Preferred Project Report

prepared in respect of MP06_0273 (MOD 1)
for the Development of

SITE 4B

SYDNEY OLYMPIC PARK

3. Revolving Doors

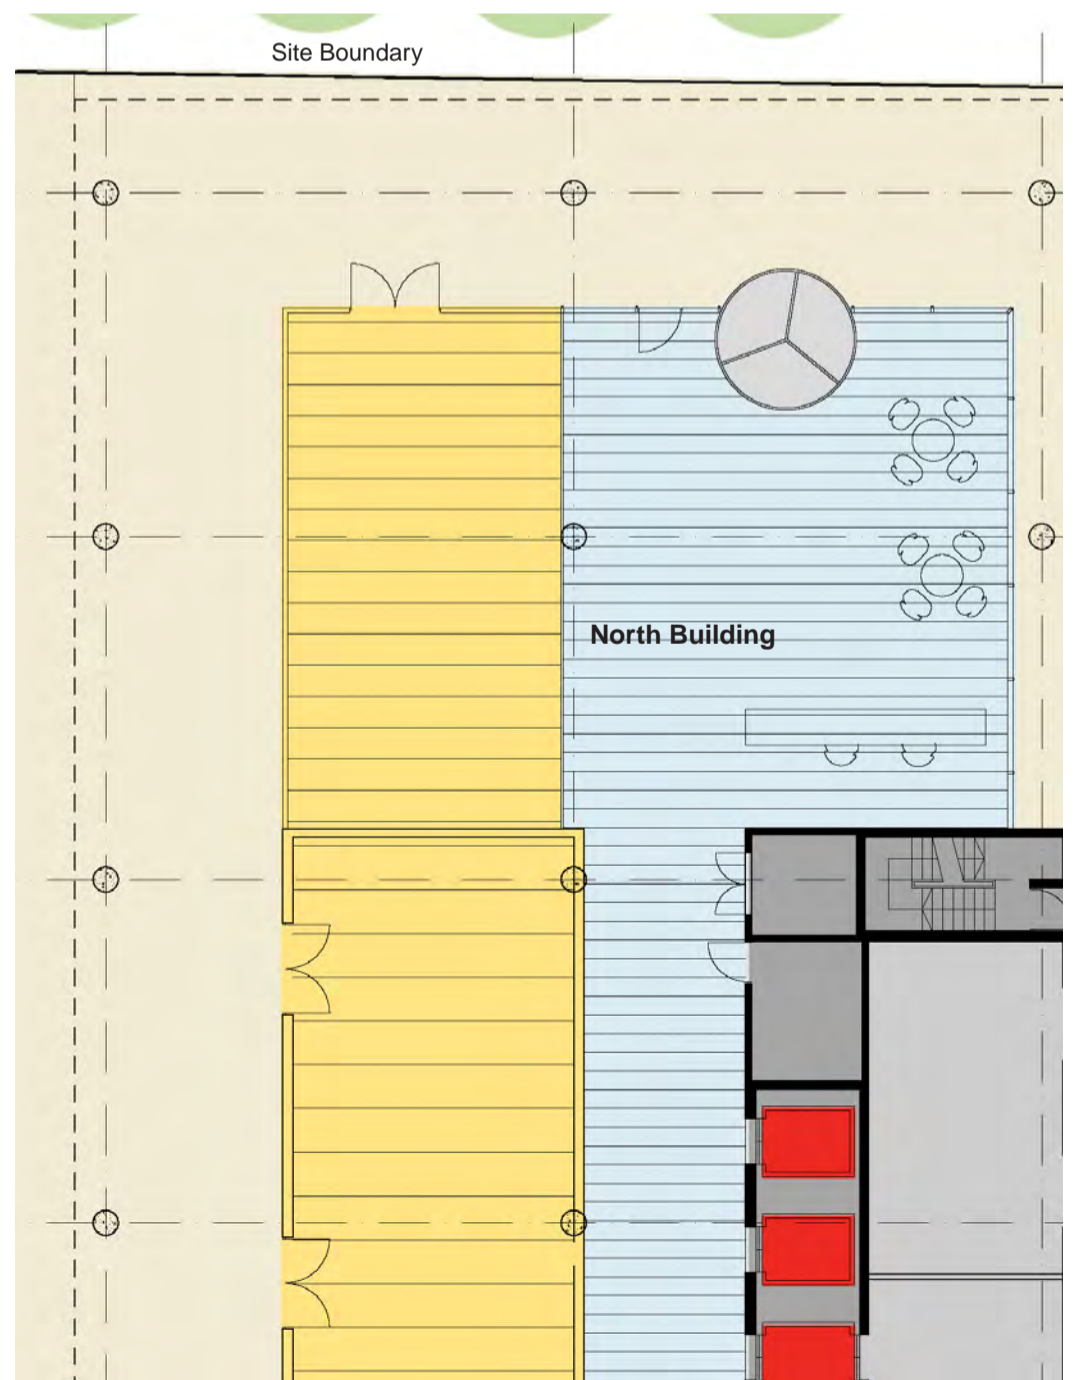
The Revolving door on the Olympic Boulevard frontage should not project into the colonnade zone as it presents a hazard to the visual and mobility impaired.

The doors will be setback 3.5m from the property boundary and 9.5m from the Olympic Boulevard kerb edge allowing for a generous, open clear zone in which to circulate around the edge of the building.

The advice, as provided by David Goding of Morris Goding Accessibility Consultant, is that 'where the door protrudes into the colonnade, there is a rounded obstruction (door casing) that warns/affords a person a better degree of safety when negotiating the door. The proposed design with the door projecting into the colonnade is in my opinion a better option than the recessing of the door into the façade line and therefore the recommended solution.'

4. Plant Height

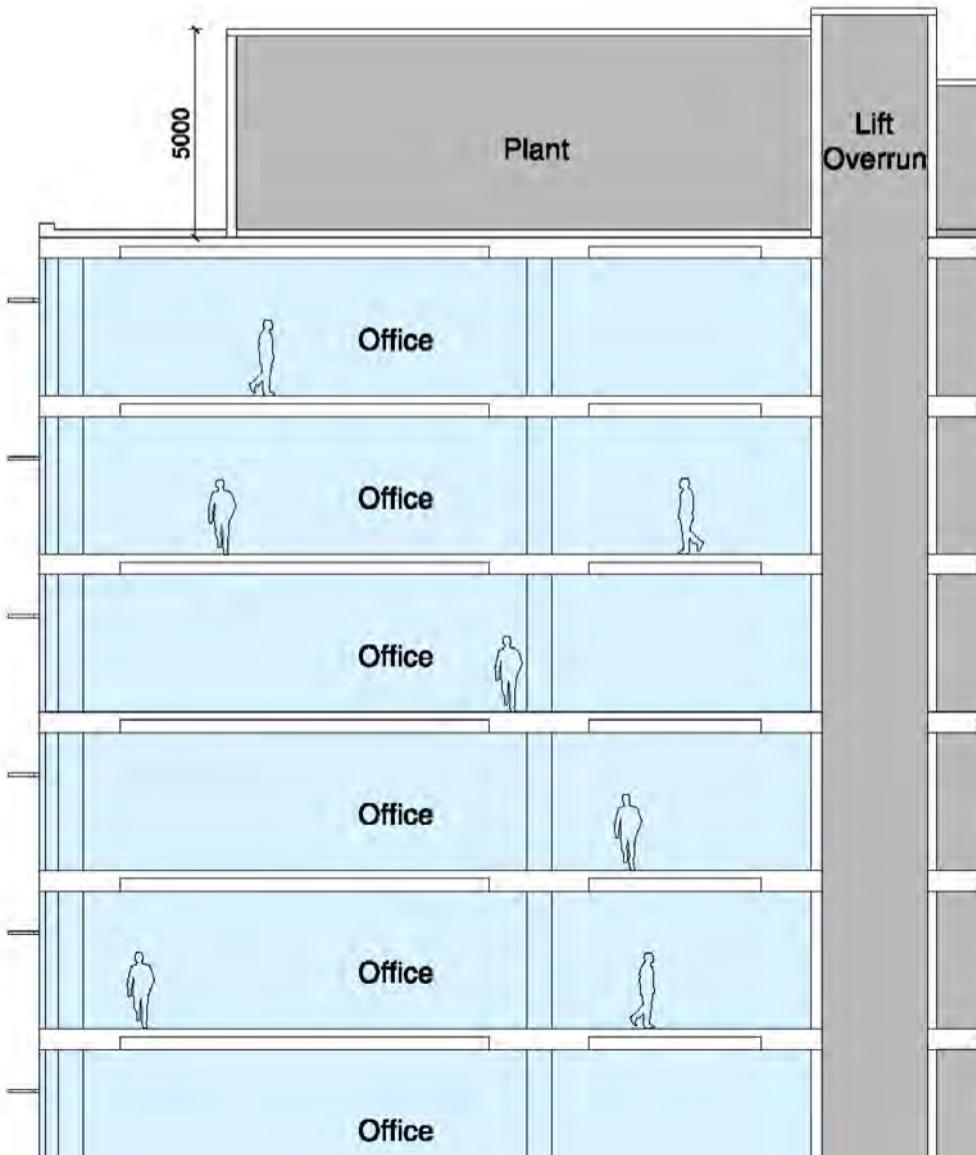
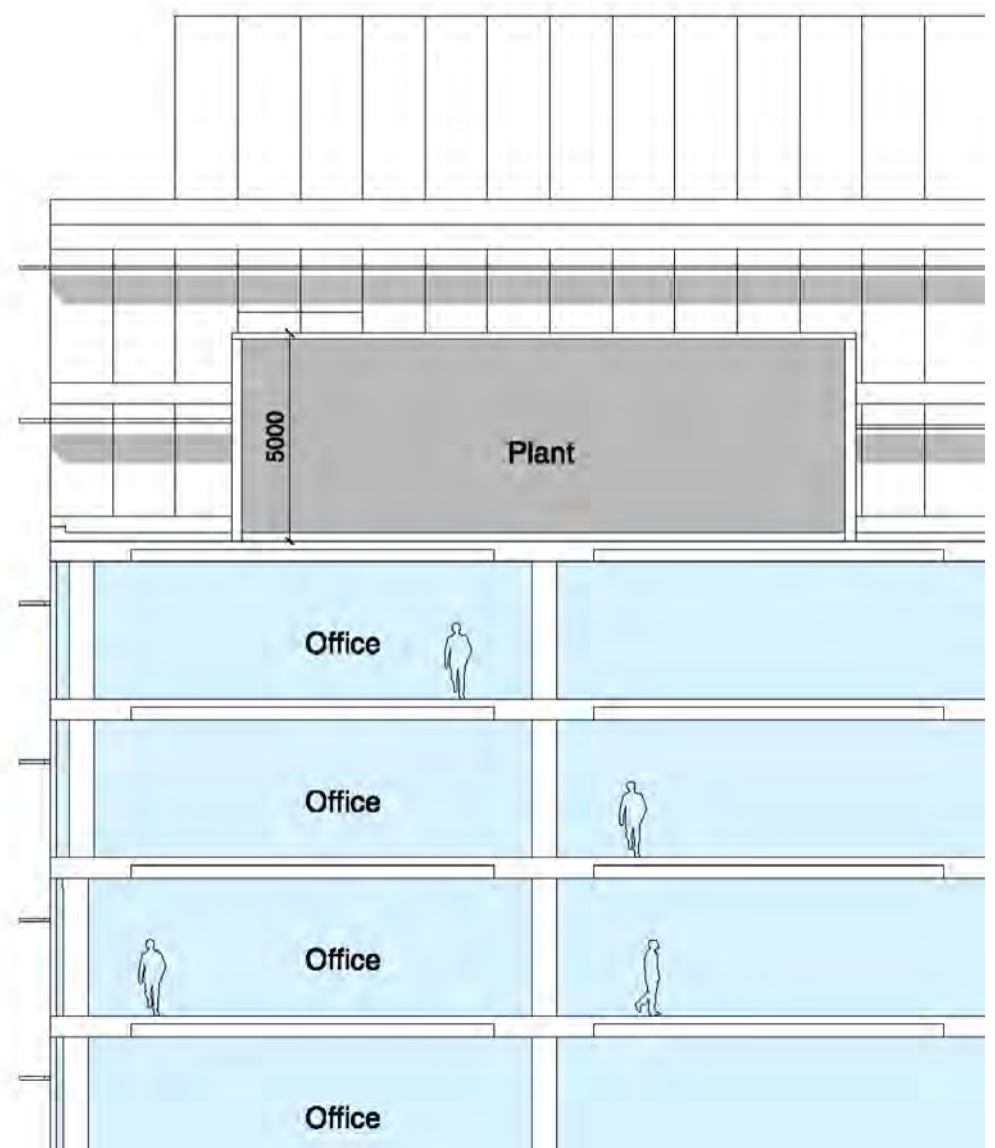
DOP Commentary
Demonstrate compliance with the maximum 5m height rooftop services zone, as stipulated within the Sydney Olympic Masterplan 2030.

Response
Generally, the maximum height of the rooftop plant zone is 5m with plant such as lift over runs and the like exceeding 5m to a maximum of 20% of the roof area.

5. Canopy to South Building

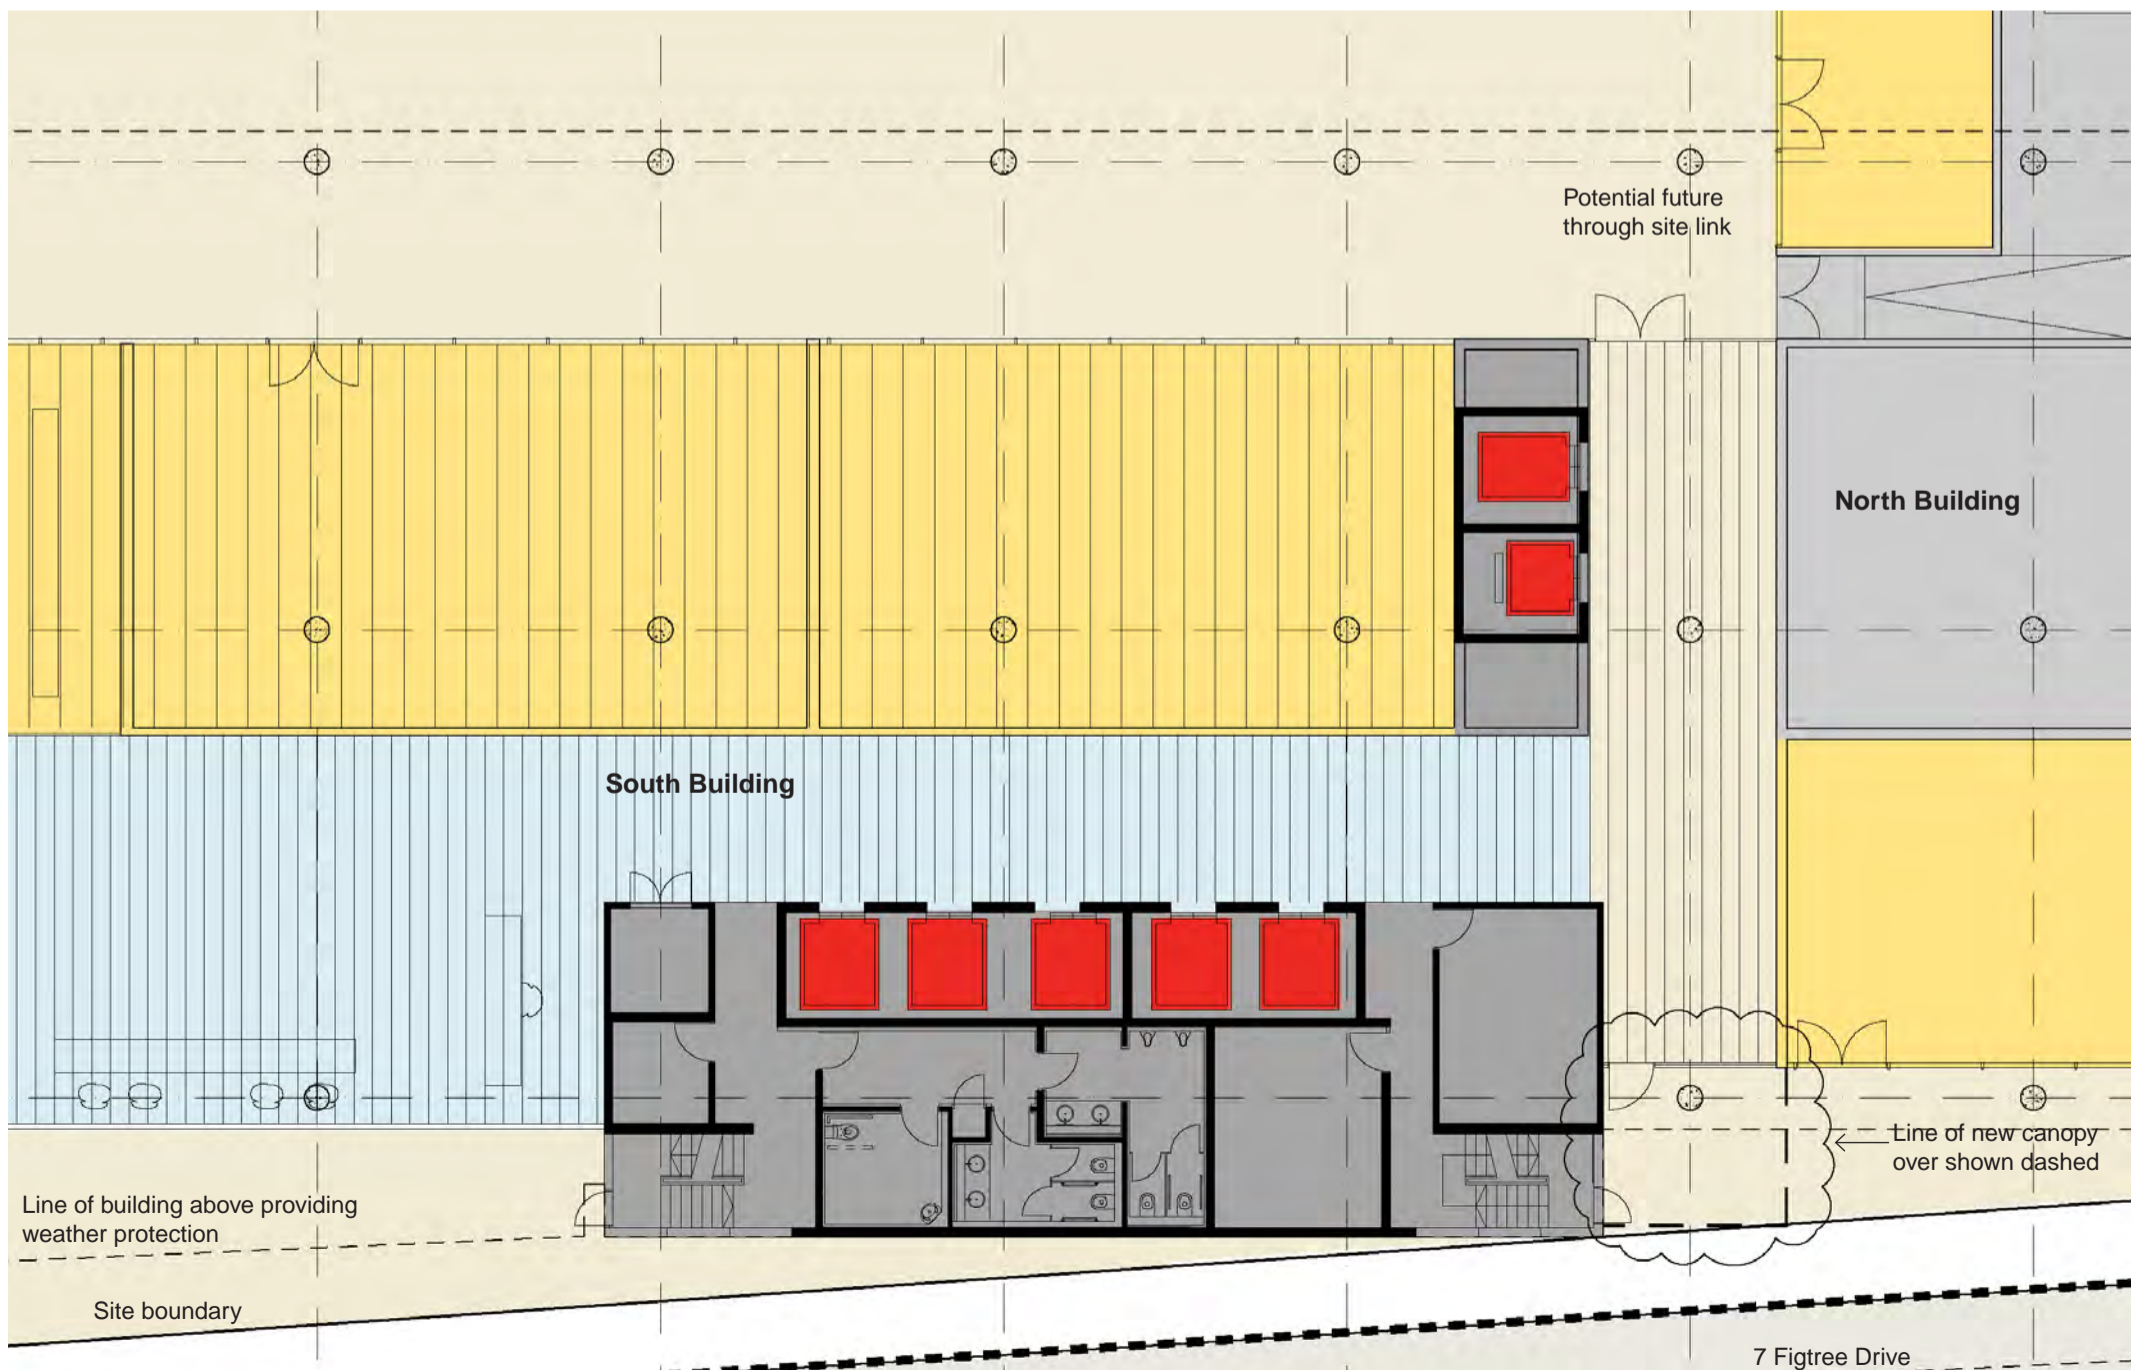
Continuous sheltered access should be provided along the Southern elevation of the South Building.

A canopy will be provided on the eastern side of the South Building as shown below. In addition the building overhang on the west side of the South Building provides extensive weather protection as shown below.
